Access Compliance Report

Public Rights-of-Way

(Curb Ramps)

Intersection ID: 10040108	Main Street: TUCKASEEGEE_RD	Cross Street: MT_CARMEL	Location: E
ADA ID: 08E1AC672B4D	Ramp Type: Directional1	Initial Pass/Fail: Fail	Overall Compliance: No
Codes/Mitigation Info/Possible Solution		Field Measurements/Component Compliance	
Severity Score: 12.5

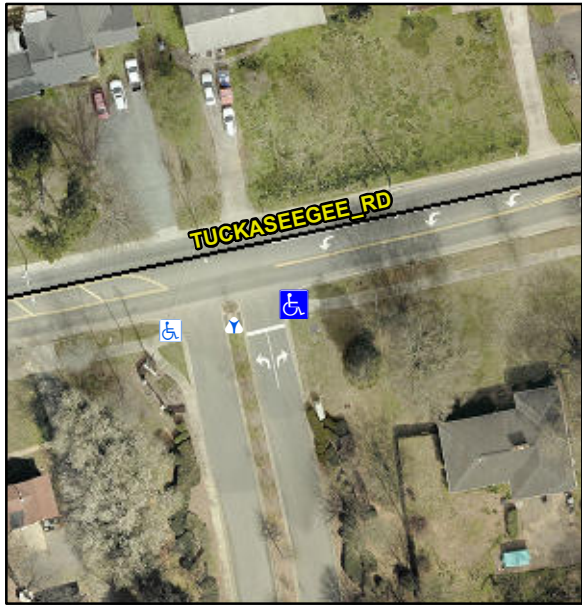
Possible Solutions:

Remove & Replace Entire Ramp.

PROW/ADA:

R304.2.2
